# UNITED STATES PATENT AND TRADEMARK OFFICE

APPLICATION NO.	FILING DATE	FIRST NAMED INVENTOR	ATTORNEY DOCKET NO.	CONFIRMATION NO.
09/633,573	08/04/2000	Wilson T. Asfora	00-0050	2575

## Office Action Summary

**DETAILED ACTION**

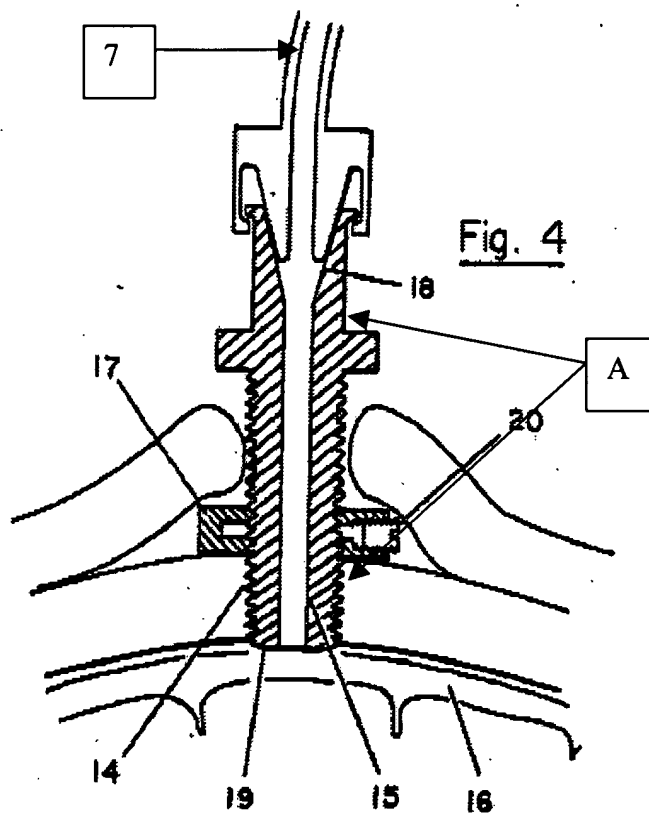
Swann et al. discloses an adjustable screw comprising a tubular portion (A, see labeled figure below) capable of being inserted into a an opening in a skull of a patient, the tubular portion having a proximal end (19) and a distal end (18) and a lumen (15) extending between the proximal and distal ends, the tubular portion having an exterior surface; a pair of wings (21) for facilitating finger rotation of the tubular portion, the wings extending outwardly from the tubular portion in substantially opposite directions from the tubular portion; self-tapping threads (14) formed on the proximal end of the tubular portion; a drill bit (32) for forming an opening in the skull of a patient; a stop collar (33) selectively lockable in a position on the drill bit for setting a maximum penetration of the drill bit into a surface; and a conduit (7).

Swann et al. fails to disclose a retaining means on the exterior surface of the tubular portion adjacent to the distal end for engaging an interior surface of a conduit with a flexible wall to releasably retain the conduit on the distal end of the tubular portion.

Huppee discloses a barbed tubing connector (10) comprising a tubular portion (12) including retaining means (18) on the exterior surface of the tubular portion adjacent to the distal end for engaging an interior surface of a conduit with a flexible wall to releasably retain the conduit on the distal end of the tubular portion.

It would have been obvious to one having ordinary skill in the art to have modified Swann et al. with a retaining means as taught by Huppee so as to enable higher operating

pressures while maintaining a leak free connection without the need for complex connection means on the cooperating end of the flexible conduit.

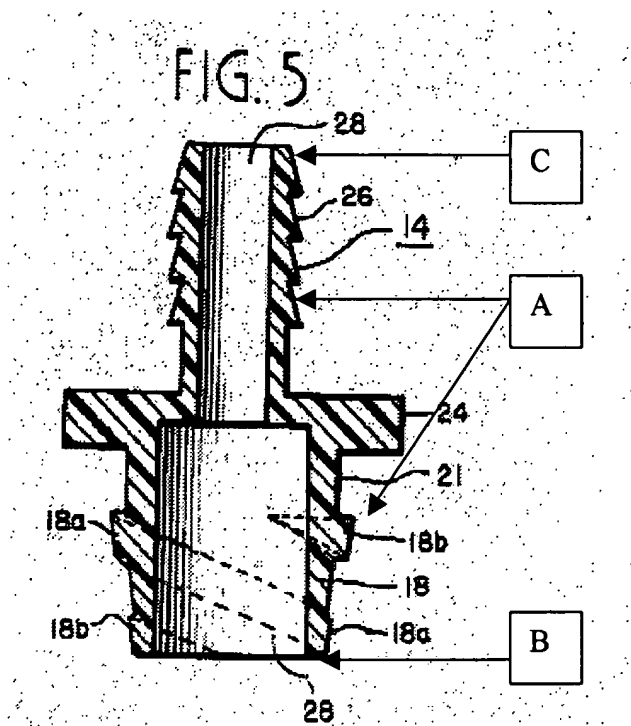
Akers discloses a connector (10) comprising a tubular portion (A, see labeled figure below) capable of being inserted into a an opening in a skull of a patient, the tubular portion having a proximal end (B, see labeled figure below) and a distal end (C, see labeled figure below) and a lumen (28) extending between the proximal and distal ends, the tubular portion having an exterior surface; retaining means (26) on the exterior surface of the tubular portion adjacent to the distal end for engaging an interior surface of a conduit with a flexible wall to releasably retain the conduit on the distal end of the tubular portion; and self-tapping threads (18a, 18b) formed on the proximal end of the tubular portion.

Akers failed to disclose a pair of wings for facilitating finger rotation of the tubular portion, the wings extending outwardly from the tubular portion in substantially opposite directions from the tubular portion.

Berg discloses a tap comprising a tubular portion (11) including a pair of wings (14, 14') for facilitating finger rotation of the tubular portion, the wings extending outwardly from the tubular portion in substantially opposite directions from the tubular portion.

It would have been obvious to one having ordinary skill in the art to have modified Akers connector with a pair of wings as taught by Berg to provide means for providing torque to the connector so as to aid in manually threading the connector into the opening.
